Dixon Public Library
230 N First Street, Dixon Ca 95620

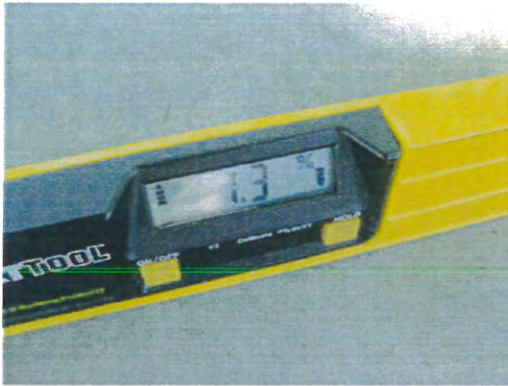
Public right of way North First Street-
Needs directional access signage

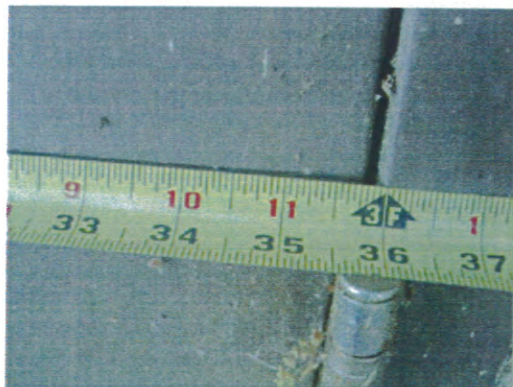
Door kick no compliant at less than 10"

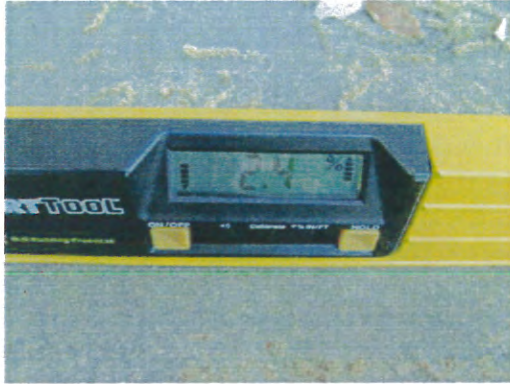
Landing running slope not compliant at more than 2%

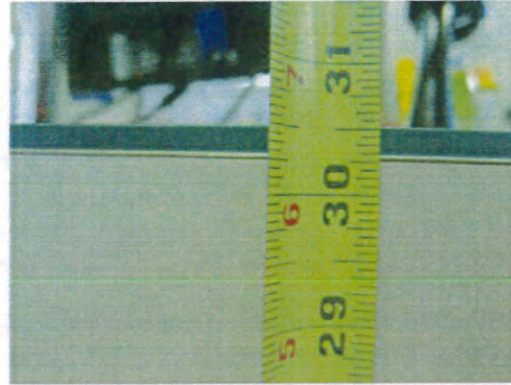
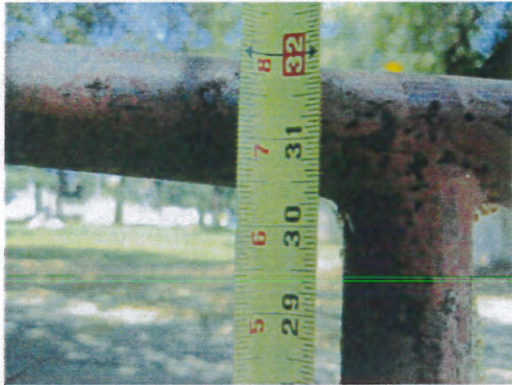
Ramp rails no compliant with height, wheel guides or rail extensions

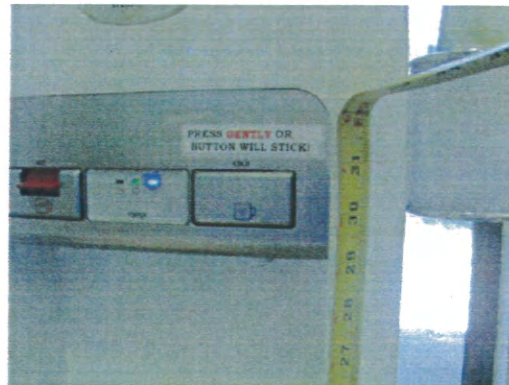
Drinking fountain not accessible to the disabled. Alternate water cooler provided

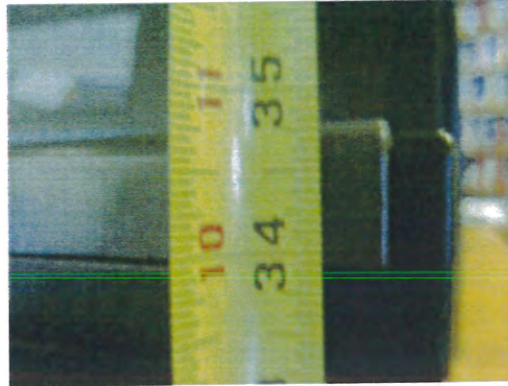
To make ends of tables accessible as seating location extend tops to 19" minimum clear

Internet reservation computer not on accessible table. No under table clearance for legs

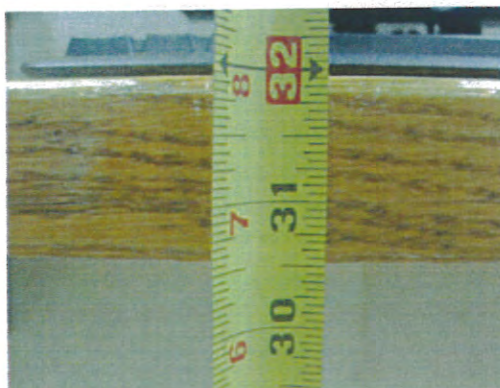
Library book catalog computers.
Disabled access computer shelf not
compliant at less than 19" deep. Height
of shelf compliant

Exit Route signage is not clear or consistent. Recommend revising any signs referring to path of exit and add Braille signage for Exit Route

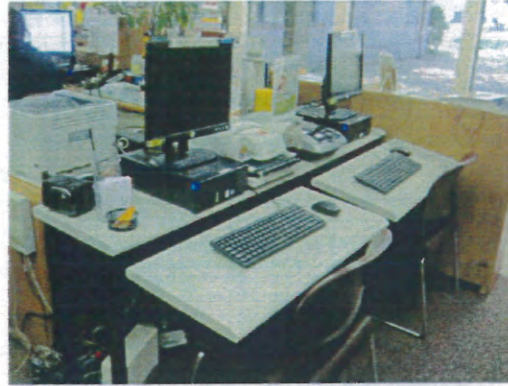
Exit Route signage is not clear or consistent. Recommend revising any signs referring to path of exit and add Braille signage for Exit Route
